July 2, 2015  
 Alberta Technology Center  
 Owner: The City of Tuscaloosa  
 Owner's Project No: A15-0513  
 Architect: Ward Scott Architecture, Inc.

This Addendum forms a part of the Contract Documents and modifies the original Bid Documents dated June 22, 2015, as noted below.

**Addendum No. 3 - Structural Items**  
**July 2, 2015**

2 EAST ELEVATION  
1/4" = 1'-0"

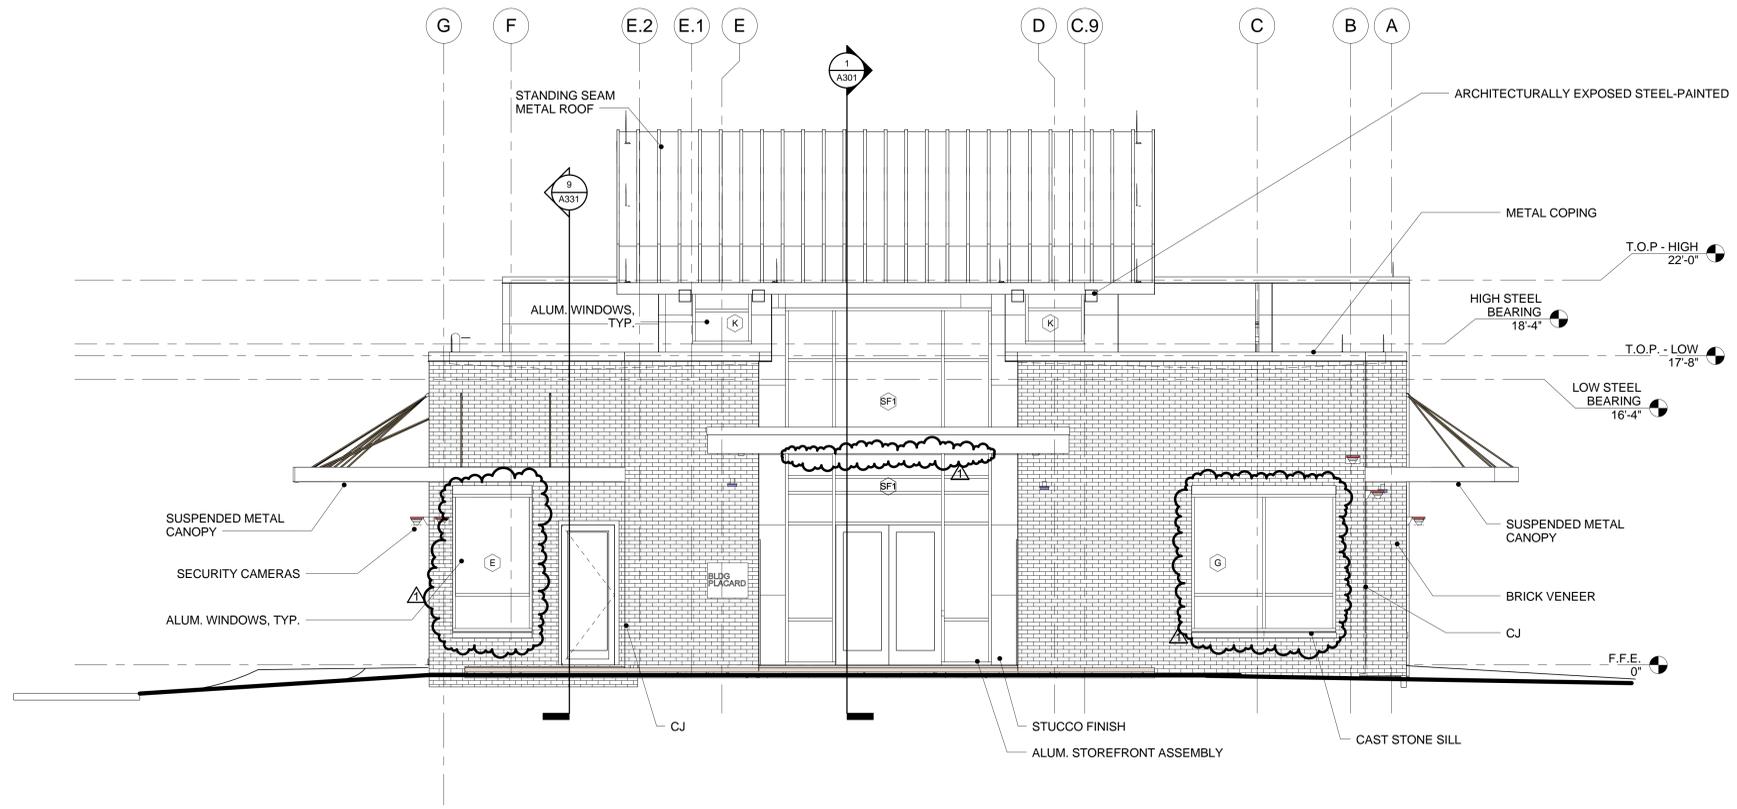
8. A201 Exterior Elevations. Detail 1 - window size adjustments, new door transom and cast stone headers (typical).
9. A202 Exterior Elevations. Detail 2 - window size adjustments, new door transom and cast stone headers (typical).

5 WALL SECTION - WINDOW - A  
3/4" = 1'-0"

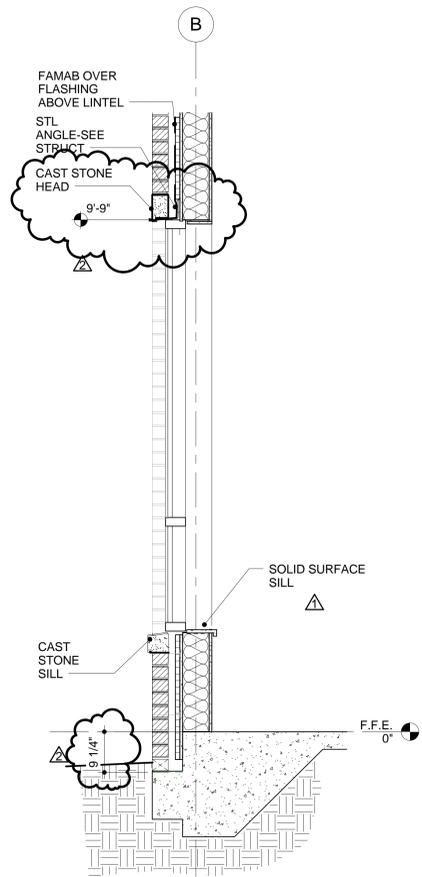
10. A311 Wall Sections. Note storefront windows in masonry wall to be typical per new detail 5/A311. Wall section at Cast Stone window (Detail 4) has been modified. Details 6, 7, and 8 have been deleted.
